Access Compliance Report

Public Rights-of-Way

Intersection ID: 22484	Main Street: RIVER_OAKS_LN	Cross Street: SHARON_VIEW_RD	Location: NE
ADA ID: 4D9C8B187CAF	Ramp Type: PerpDiag	Initial Pass/Fail: Fail	Overall Compliance: No
		Severity Score: 8.75

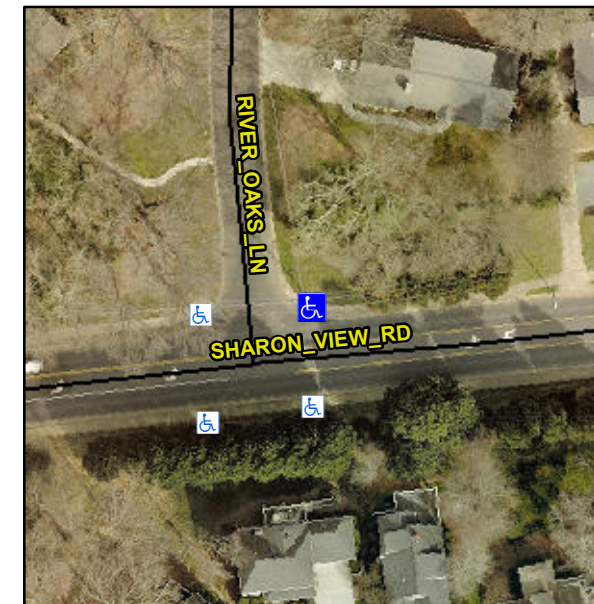
Not Found, R304.5.1

Compliance	Description	Data	Compliance	Description	Data
N/A	Ramp Length (in)	57.0	Yes	Ramp Slope (%)	6.5
No	Ramp Width (in)	42.0	Yes	Ramp XSlope (%)	1.3
N/A	Flare Type LT	N/A	N/A	Flare Type RT	N/A
N/A	Flare Slope LT (%)	N/A	N/A	Flare Slope RT (%)	N/A
N/A	Flare Traversable LT?	N/A	N/A	Flare Traversable RT?	N/A
N/A	Landing Length (in)	N/A	N/A	DWS Provided?	N/A
N/A	Landing Width (in)	N/A	N/A	DWS Contrast?	N/A
N/A	Landing Slope (%)	N/A	N/A	DWS Length (in)	N/A
N/A	Landing X Slope (%)	N/A	N/A	DWS Full Width?	N/A
N/A	Landing Curb? (Y/N)	N/A	N/A	DWS Offset (in)	N/A
N/A	Shared Landing?	N/A			
N/A	Gutter Ponding?	N/A	N/A	Gutter Slope (%)	N/A
N/A	Gutter Lip Ht (in)	N/A	N/A	Gutter X Slope (%)	N/A
N/A	Painted X Walk1?	No	N/A	Painted X Walk2?	No
	X Walk 1 Direction	To W		X Walk 2 Direction	To S
N/A	X Walk 1 Width (in)	N/A	N/A	X Walk 2 Width (in)	N/A
	X Walk 1 Slope (%)	0.2		X Walk 2 Slope (%)	0.1
	X Walk 1 X Slope (%)	0.2		X Walk 2 X Slope (%)	0.4

Remove & Replace Curb Ramp With Two New Directional Ramps or Equivalent.
